SUBJECT: Part 21 rept re 980427 possible defect in Cutler-Hammer 4 pole front attachments utilized on D26 relays. Caused by contact bridges turned upside down. Retraining of assembly personnel, updating procedures & checks on future lots.

Subject: 10CFR21 notification of a possible defect in Cutler-Hammer 4 pole front attachments P/N: D26MF utilized on D26 Relays.

RENEWAL PARTS AND INSTRUCTIONS FOR FOUR POLE ATTACHMENT (TYPE M RELAY)

FOUR POLE ATTACHMENT

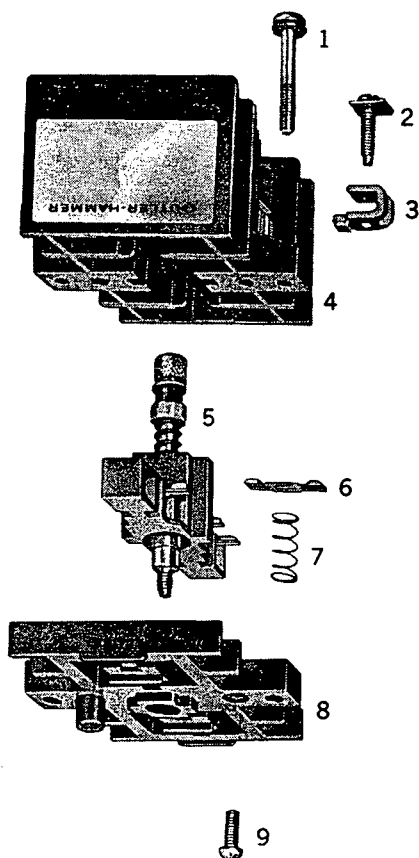
This letter is issued to inform you of a possible assembly defect in Cutler-Hammer four pole attachments, P/N: D26MF, utilized on D26 relays. On April 27, 1998, Duke Power notified EGS that they had found 2 ea. P/N: D26MF, four pole attachments, date codes 09961 and 07964, that had some or all of the contact bridges turned upside down, causing the thin bare copper strip instead of the silver plated pads to interface with the stationary contacts. This condition can potentially cause increased contact resistance and/or insufficient current carrying capabilities over time due to the degradation of the reverse side of the contact bridge.

It is recommended that all four pole attachments supplied under the affected orders be visually inspected to verify proper contact bridge orientation. This can be done by removing the four pole attachment from the relay and removing the molded base and contact carrier exposing the contact bridges or by removing the stationary contacts and inspecting the contact bridges using a small flashlight (see disassembly instructions per Attachment 2).

To remove the attachment from the relay merely backout the pullrod and mounting screws. Replace the relay cover plate if operation of relay must be continued. To remove contacts in the contact carrier (item 5) first remove holding screw (item 9) and molded base (item 8). To replace a contact bridge (item 6) depress bridge and spring (item 7) to clear retaining guide bar and slide the old bridge assembly out. Tweezers or similar tool will aid in replacing springs if this becomes necessary. To remove a stationary contact (item 3) first remove the terminal screw (item 2) completely before pulling contact from chamber. Where position is important parts have been keyed for proper alignment for all except the terminal screw pressure plates which must be oriented with the lip to the outside.
